W-6 UPPER SEGMENT: HWY 90 TO SW MILITARY DRIVE SEWER MAIN PROJECT
Solicitation Number: CO-00317
Job No.: 19-4519

ADDENDUM 6
April 9, 2020

RESPONSES TO QUESTIONS

DATE: APRIL 2020	SAWS PROJECT NO. 19-4519	SHEET NO. G32
DESIGN: JKN	KHA PROJECT NO. 068665052	
DRAWN: DJC		
CHECKED: JAF

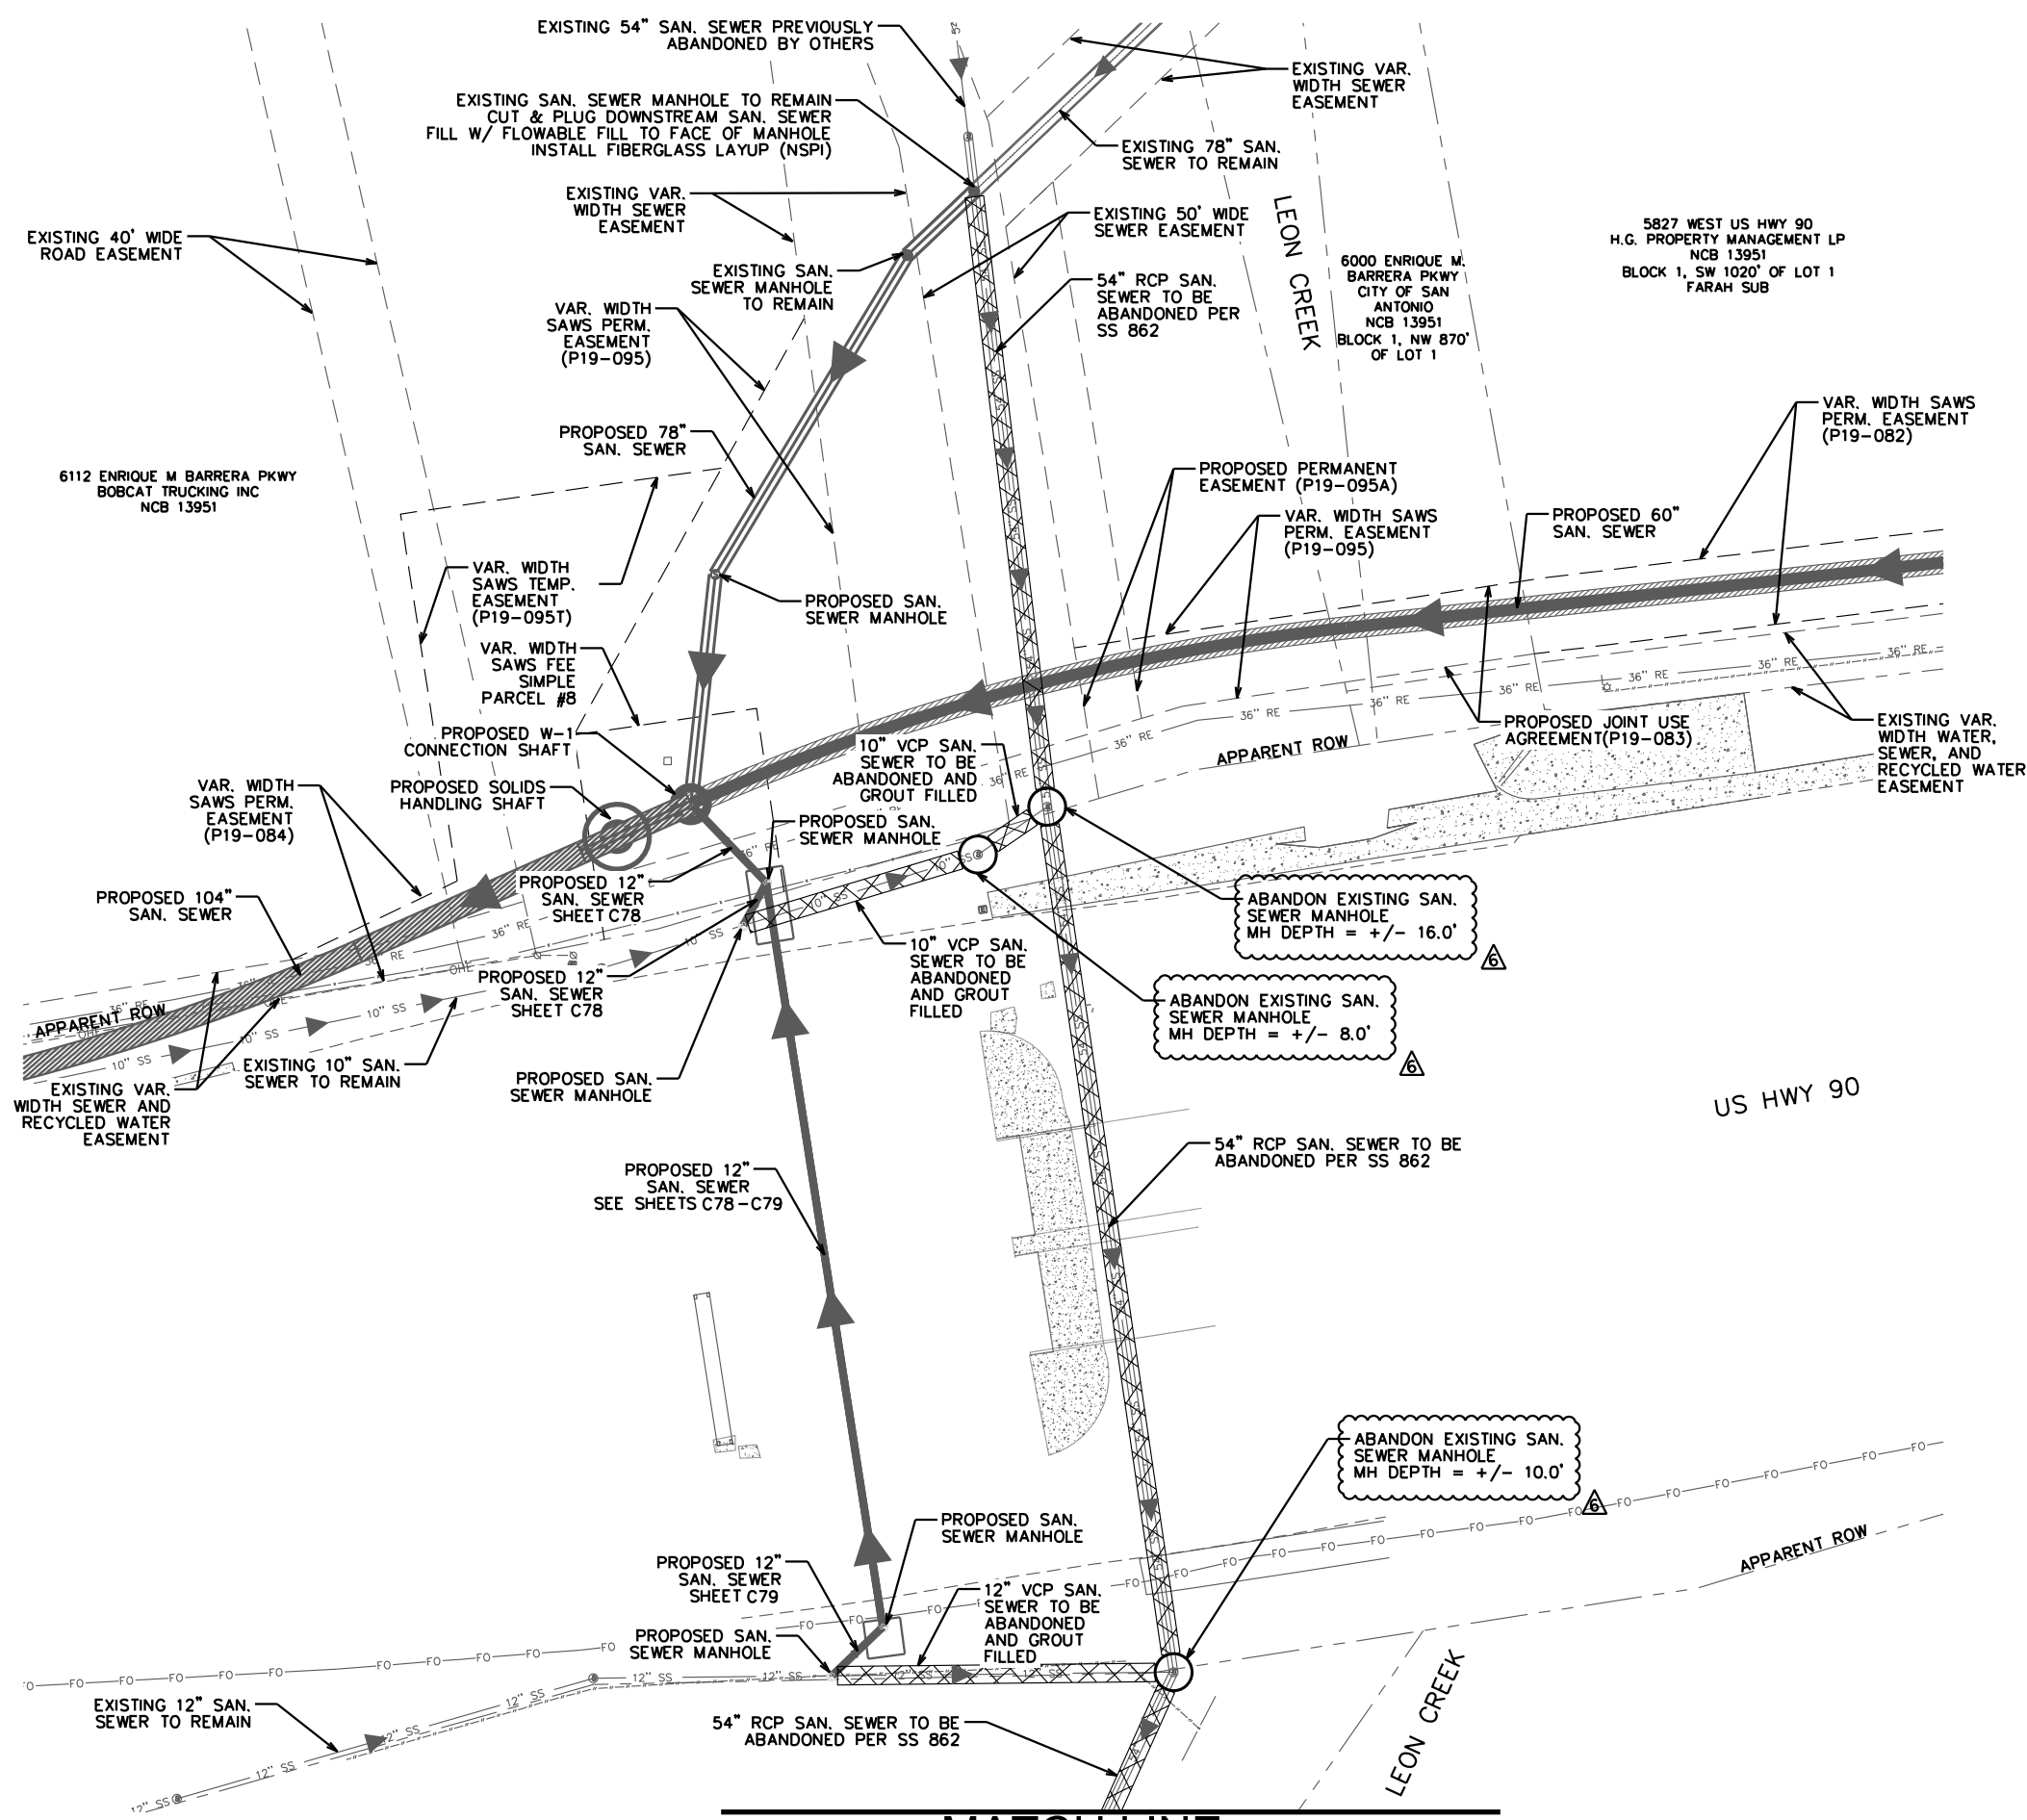
Q70: The response to Question 7 in AD-4 states that the W-1 Leon Creek: Hwy 151 to Hwy 90 - Lower Segment Project is estimated to be completed by 5/18/2021. It also states that access to the overlapping construction area on Sheet G32 is not available until that construction is complete. Sheet G32 does not clarify which areas are overlapping, only that the W-1 Contractor will be occupying part of the allowable work area at this site. Is the entire Shaft #6 and #7 site as shown on G32 unavailable to start work until 5/18/2021?

1. Sheet G32 – Contractor Access and Staging Plan (Sheet 4 of 6) – Revise and replace sheet in its entirety
 - Add line around the W-1 project construction area.
 - Add callout, “W-1 LOWER SEGMENT PROPOSED CONSTRUCTION AREA, SEE NOTE 6”
2. Sheet G34 – Abandonment Plan (Sheet 1 of 4) – Revise and Replace sheet in its entirety.
 - Added approximate depth to manhole abandonment callouts
3. Sheet G35 – Abandonment Plan (Sheet 2 of 4) – Revise and Replace sheet in its entirety.
 - Added approximate depth to manhole abandonment callouts

Response: *See revised Sheet G32 in this addendum, revised to clarify easements in use for W-1, that are not to be used for W-6 until after 5/18/21.*

ABANDONMENT PLAN
(SHEET 1 OF 4)

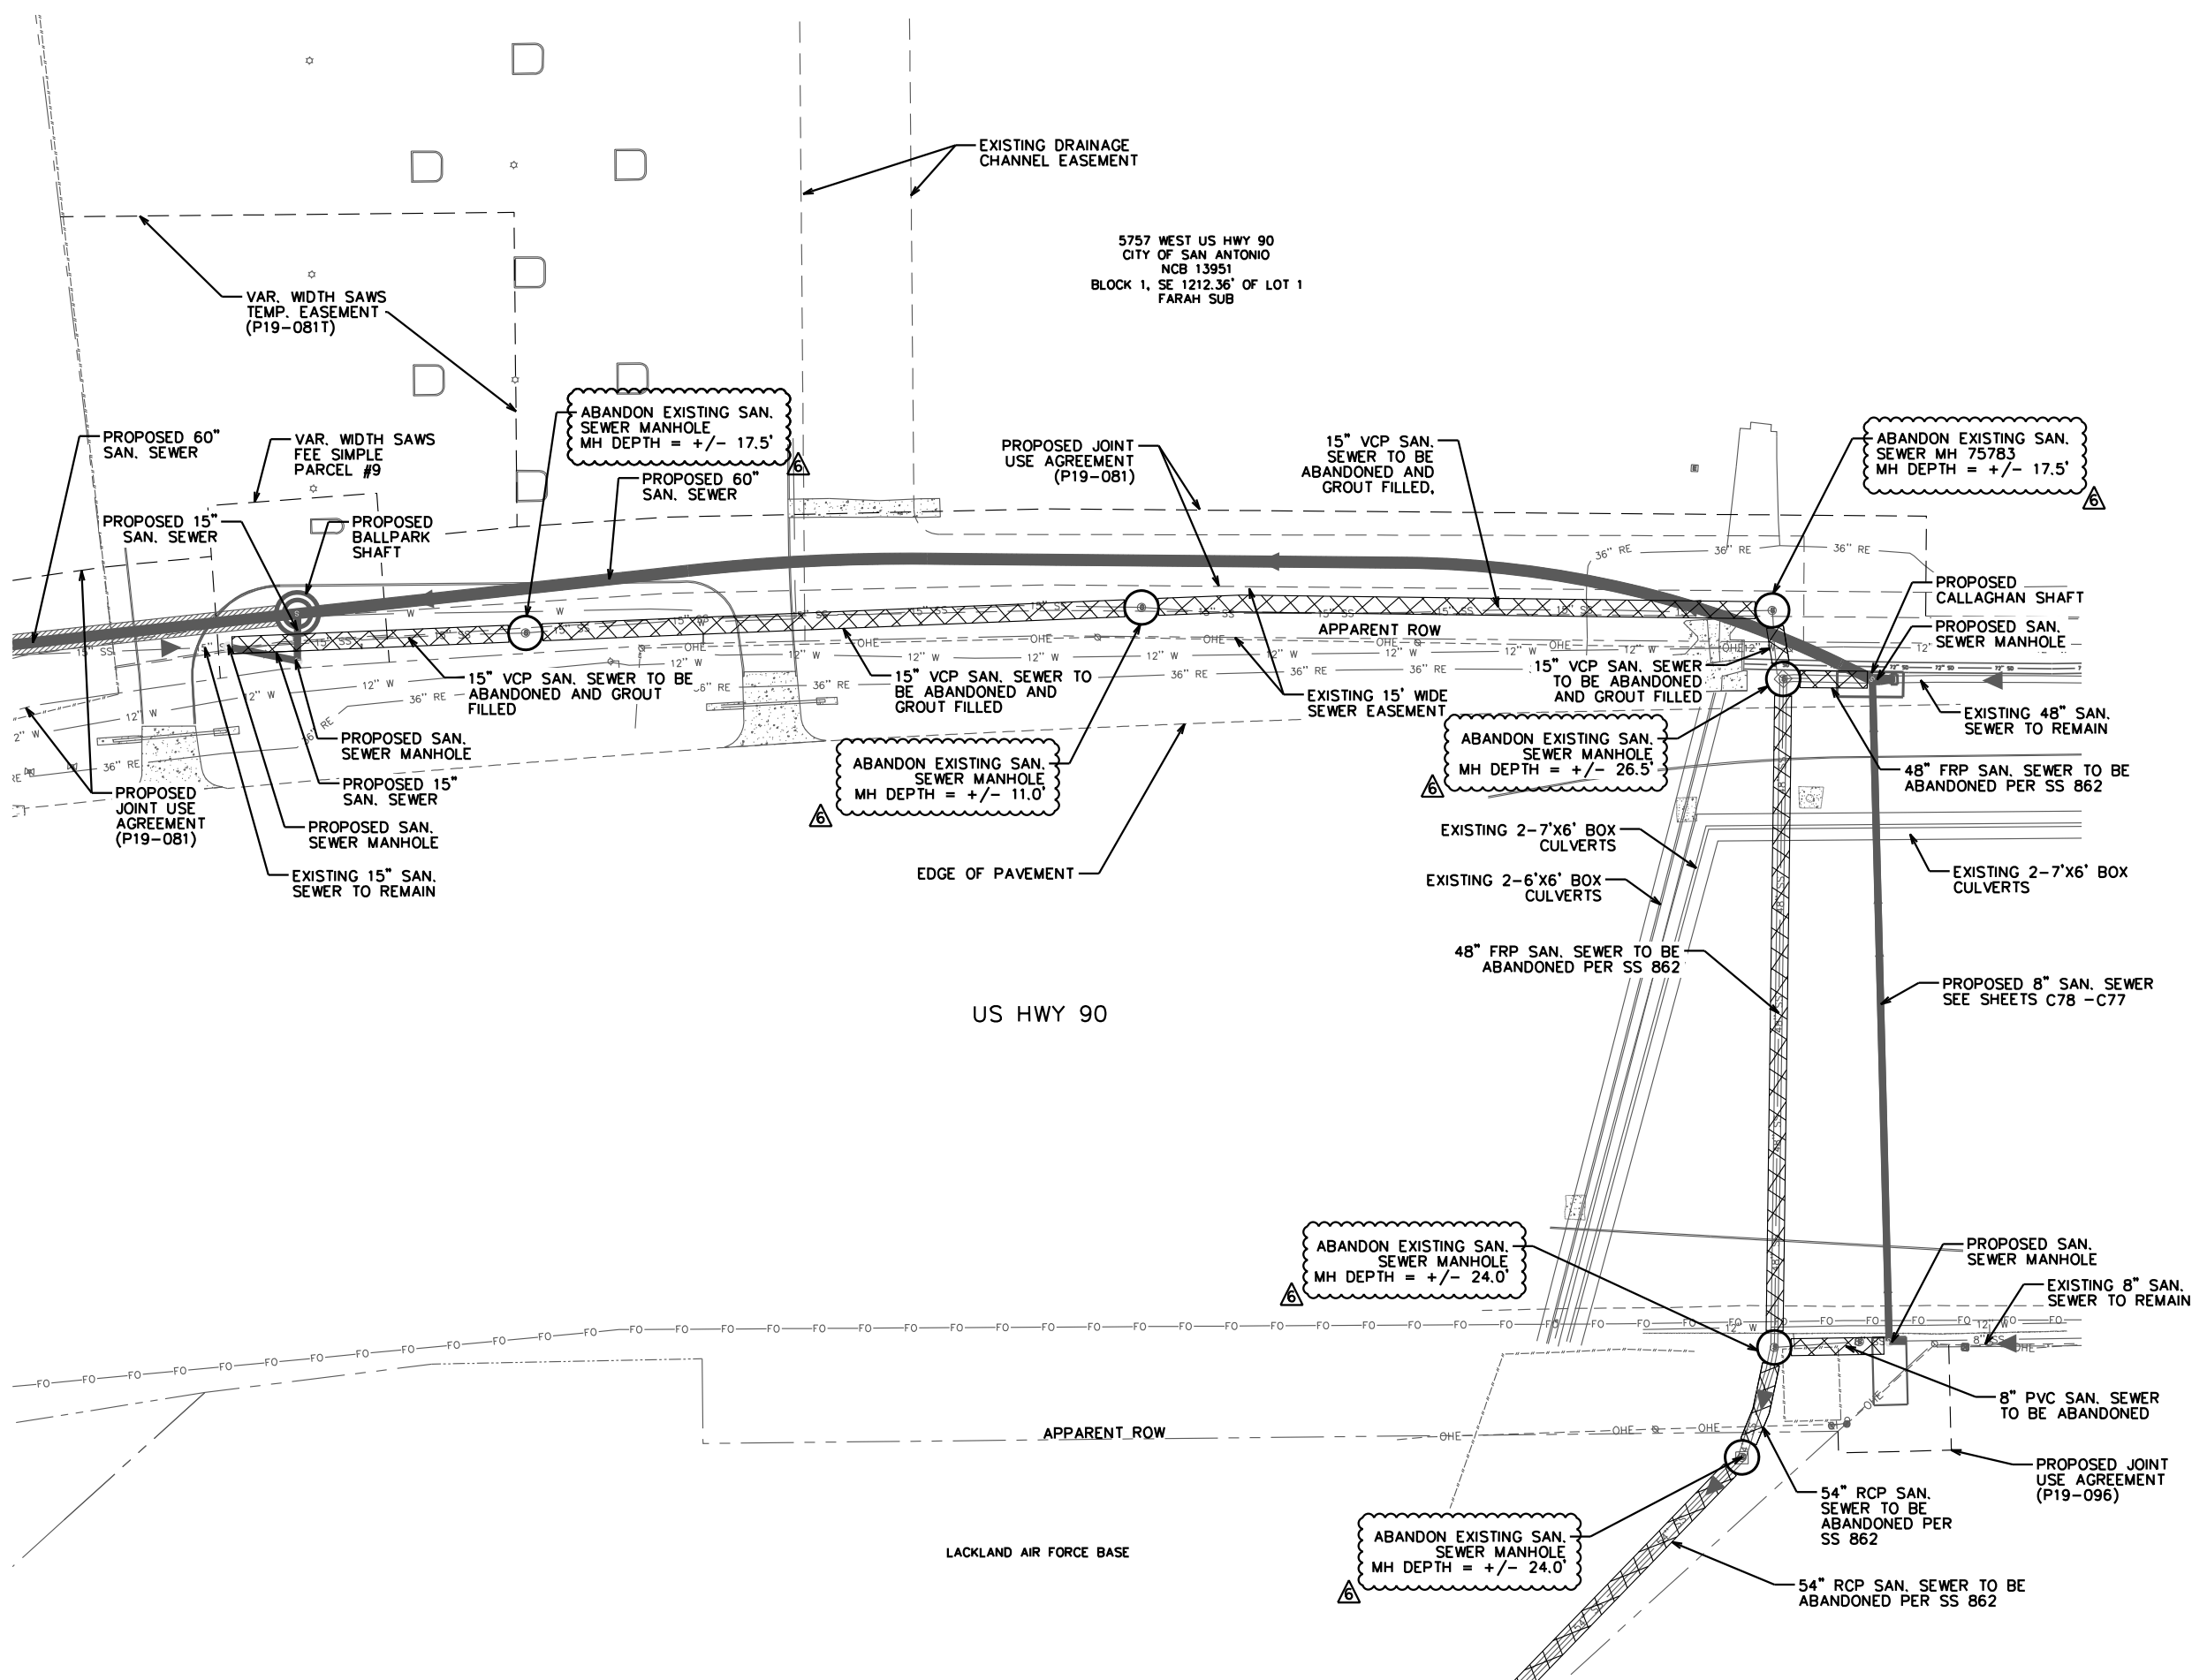
Question: States sanitary sewer manhole shall be filled to the top of the remaining concrete structure with the same material used to abandon the sanitary sewer main. Please provide top, and invert elevations of structures to be abandoned on Sheet G34 though G37

Response: *The depth of manholes to be abandoned has been added to sheets G34-G37, and the revised sheets have been added to this addendum. Please note that the depths provided were taken from SAWS block maps, and are approximate.*
